Review of Environmental Factors Addendum

Thompsons Creek and South Creek Catchments Wastewater Network

Figure 1 Major components of the project described in the REF

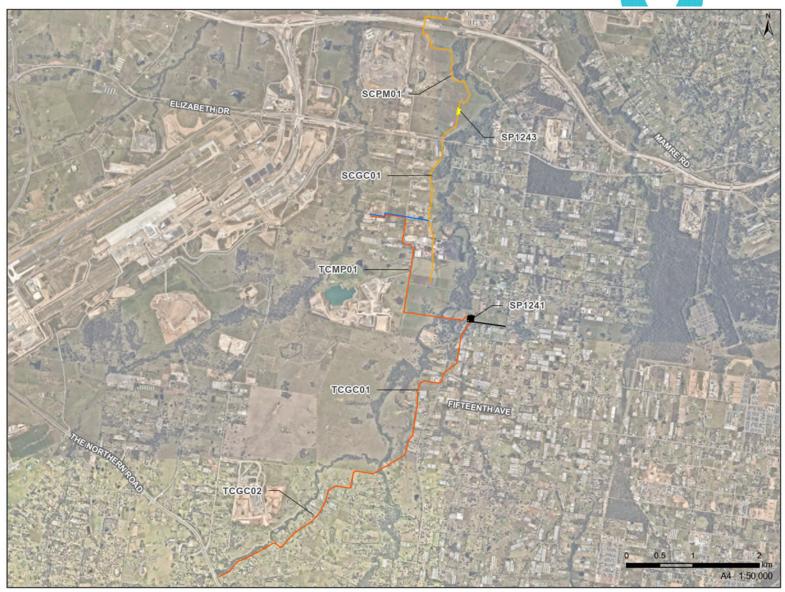
The project change will also add a connection to the existing recycled watermain which will be repurposed to convey sewerage from the Western Sydney Airport. This connection is located in the southern portion of SCGC01. This project change is within the REF construction corridor.

This project change is shown in Figure 1.

Figure 2 Project change

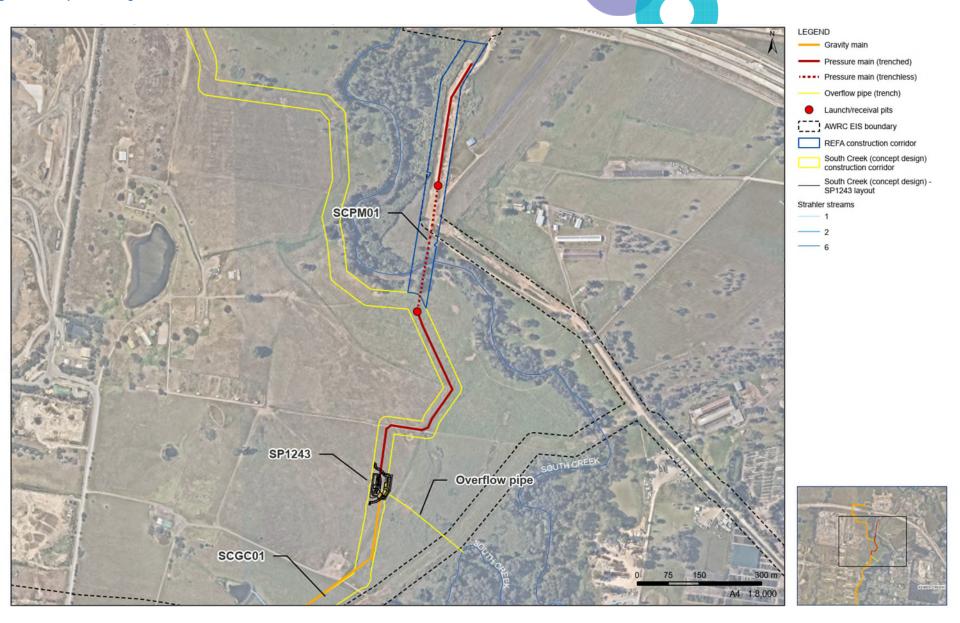
The project change will modify SCPM01. Currently, the pressure main follows the western bank of South Creek from proposed pumping station SP1243, crossing under the new M12 and then turning eastwards to cross under South Creek close to the AWRC. The proposed change is to cross under South Creek shortly after SP1243 and follow the AWRC treated water and brine pipeline corridor to the connection point south of the AWRC. Specifically, the project change will:

- Upsize pressure main from DN450 to 1 x DN1000.
- Change alignment from SP1243 to the AWRC, to include horizontal directional drill (HDD) under South Creek (reducing the length of pipeline required from about 2.5 km to 1.2 km). The entry point will be located within the REF construction corridor south of South Creek and the exit point will be located to the north of South Creek within the AWRC EIS impact assessment area. There will be a vent shaft at the entry and exit points, which will be visible during operation. Vent shafts will be about DN300 and will allow ventilation of odours from the mains at an indicative height of 18 metres. The remainder of the pipeline will be open trench and follow the 50-metre-wide AWRC EIS impact assessment area.

- An additional DN1000 pipe will be constructed in the HDD section to minimize future ground disturbance in this area. This second pipe would not be operational until a later stage of the project and these future works would be the subject of a separate REF.

These project changes are shown in Figure 2.
